**30-039-05059 MOBIL APACHE #010**

**EPIC ENERGY, L.L.C.**

Epic Energy, LLC, proposes to permanently plug and abandon the Mobil Apache #10 as per the attached procedure:

Re: Permanent Abandonment  
Well: Mobil Apache #10

**Proposed P&A**

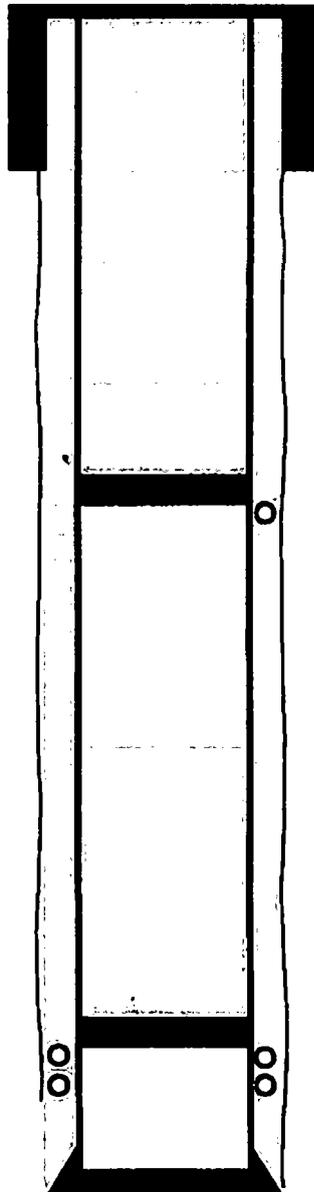
- Add a plug from 2704'-2607' to cover the Ojo Alamo top. OCD Ojo Alamo pick @ 2654'.
- Add a plug from 1505'-1405' to cover the Nacimiento top. OCD Nacimiento pick @ 1455'.

4. Based on geologic review and evidence of fresh water, place an additional plug to cover Nacimiento top inside/outside casing from 500-600 ft md with required excess volume.

5. Surface plug to extend 50' below the shoe of the 8-5/8 surface casing with no annular space left open to the drilled hole below.
